Planning Commission Minutes
September 8, 2022

14. (SPUD-1441) Application by Larson Management Company, to rezone 929 SW 88th Street from the C-3 Community Commercial District to the SPUD-1441 Simplified Planned Unit Development District. Ward 5.

STAFF REPORT
The City of Oklahoma City
Planning Commission
September 8, 2022

(SPUD-1441) Application by Larson Management Company, to rezone 929 SW 88th Street from the C-3 Community Commercial District to the SPUD-1441 Simplified Planned Unit Development District. Ward 5.

MASTER DEVELOPMENT PLAN
TO SERVE
VILLAGE PLACE
TOWNHOMES

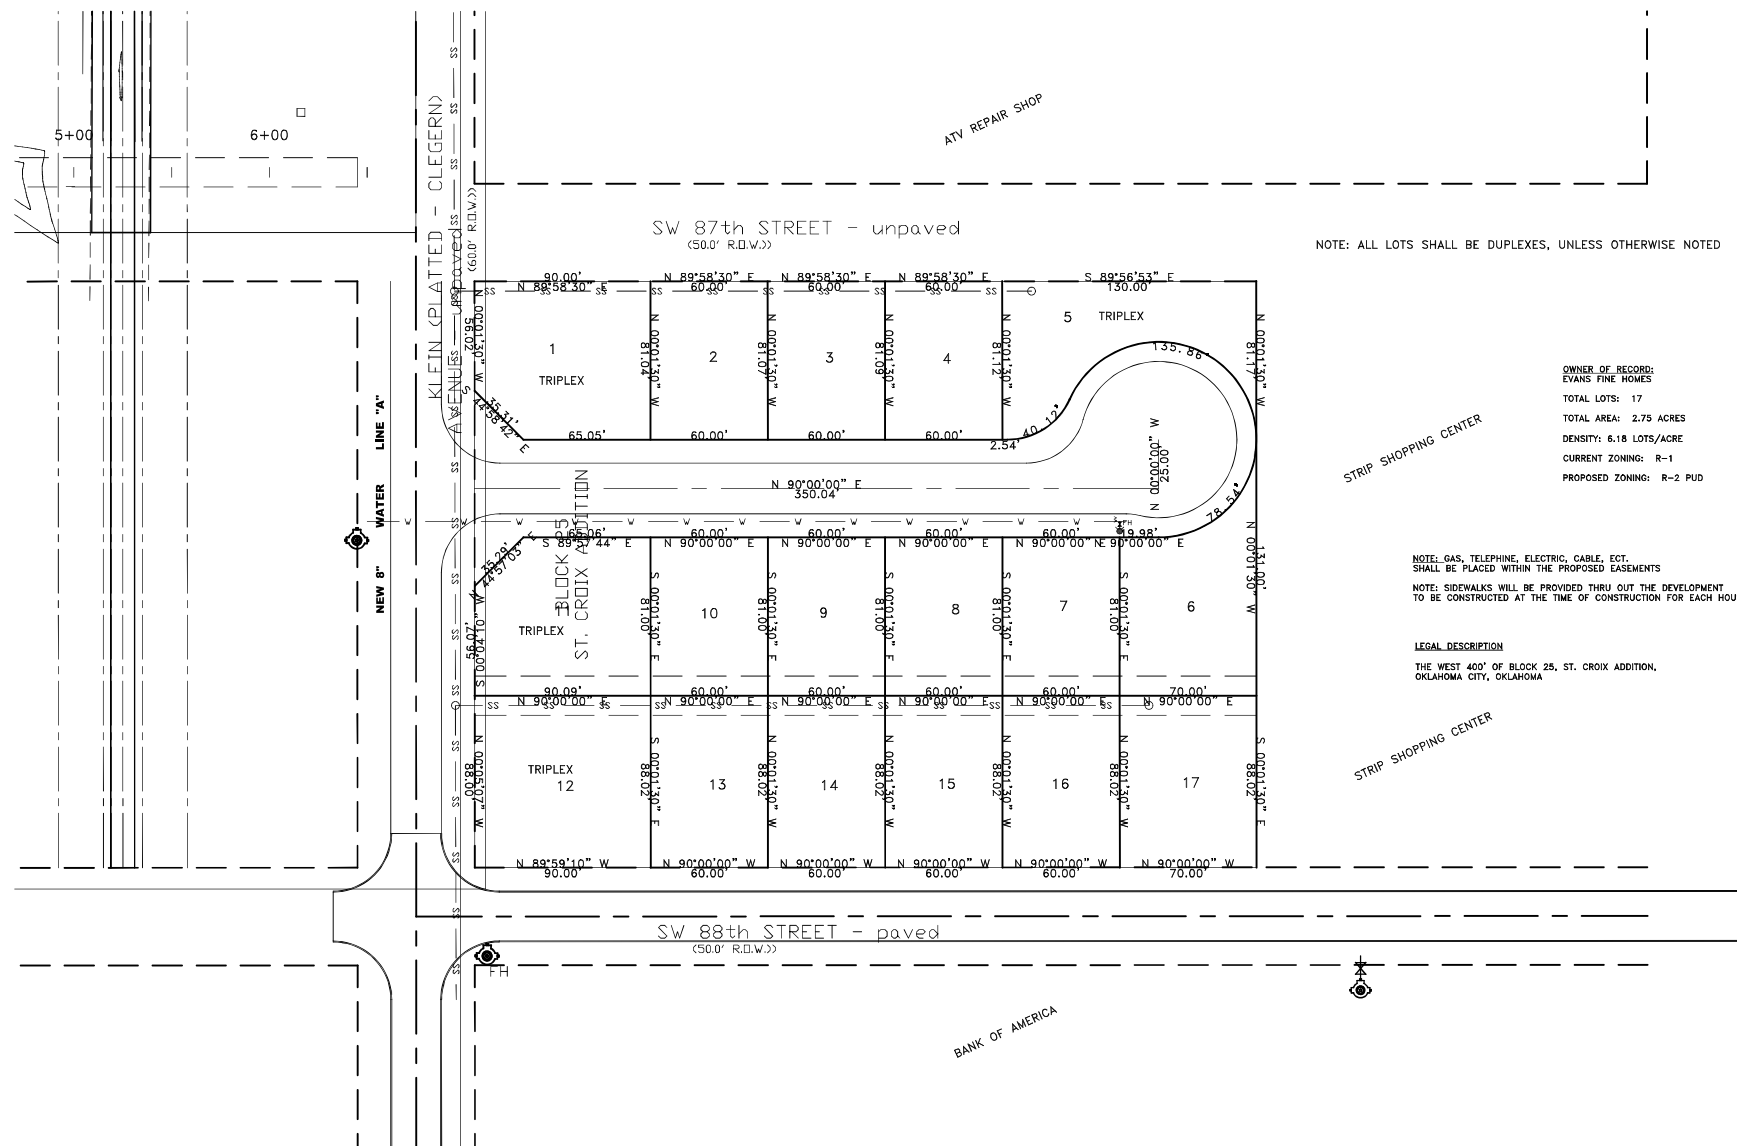
1. Remove “Triplex” from Lot 5 on Exhibit B.
2. South Klein shall be improved per City standards.

1. Remove “Triplex” from Lot 5 on Exhibit B.
2. South Klein shall be improved per City standards.
